# Work Order ID 96737

Item ID: D206-667-101

Item Name: Crosstube Fwd

DRAWING NO. D206-667-141	TITLE CROSSTUBE ASS'Y (206B HIGH FWD)	REV. C	<b>DART AEROSPACE LTD ENGINEERING ORDER</b>		D.E.O. NO. D206-667-141-C-1	SHEET NO. SHEET 1 OF 1	SCALE NTS
DRAWN <i>q</i>	CHECKED <i>ASS</i>	MFG. APPR. <i>JD</i>	APPROVED <i>MD</i>		DE APPR. <i>HA</i>		
DATE 11.07.15	DATE 11.07.20	DATE 11.07.21	DATE 11/07/21		DATE 11.07.21

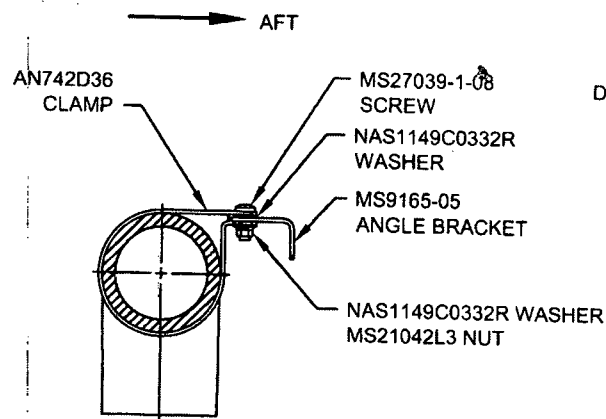
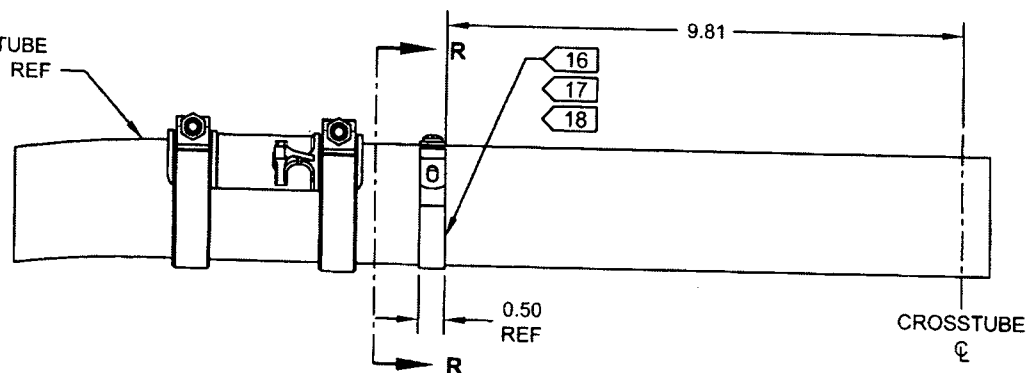
ADD ELECTRICAL GROUNDING STRAP

**DETAIL P**  
BONDING STRAP INSTALLATION 2 PL
